POLE AND BASE DETAILS FOR ROADWAY ALUMINUM LIGHT POLE

STANDARD ALUMINUM LIGHTING

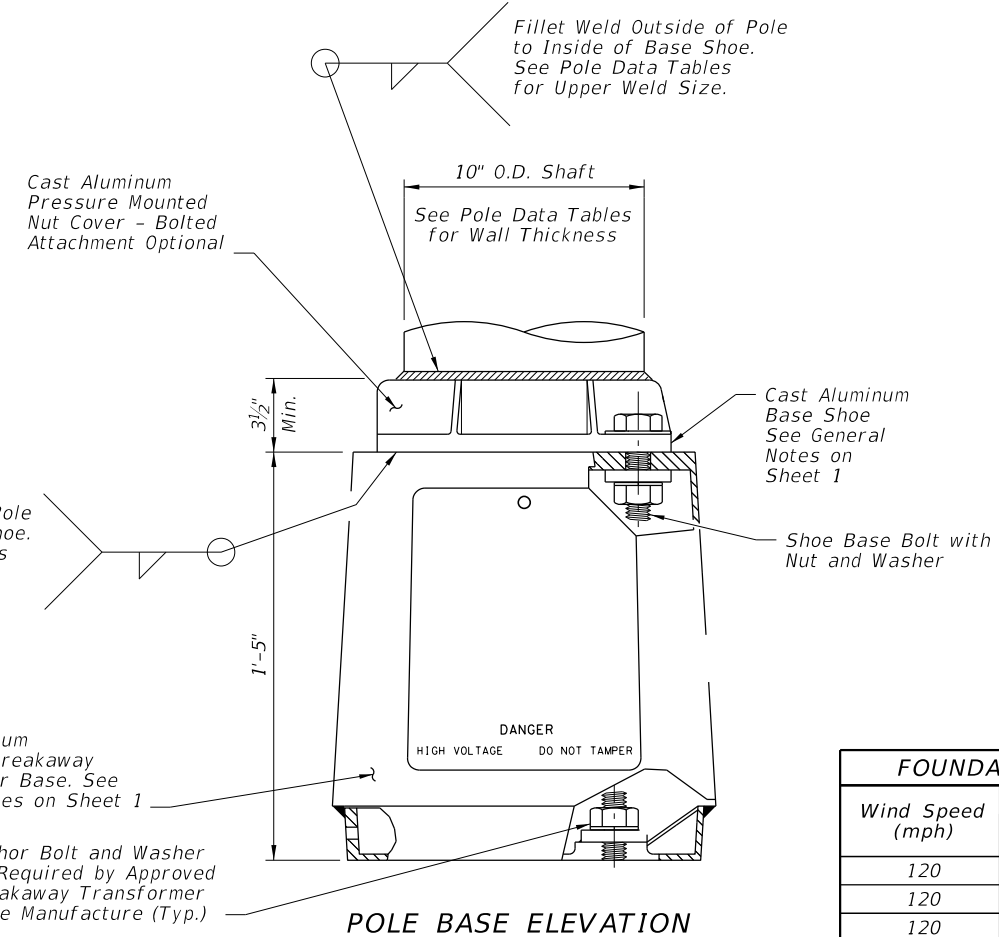
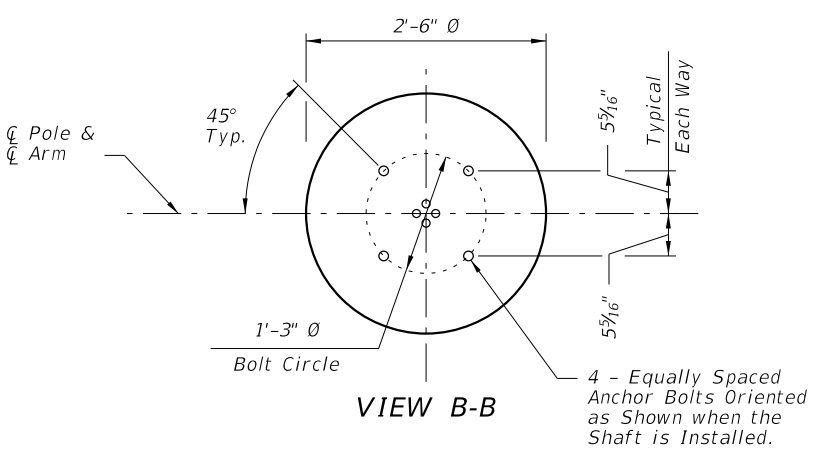
Added missing row for 140 Mph, 12 & 15 arm lengths with a mounting height of 35 feet.
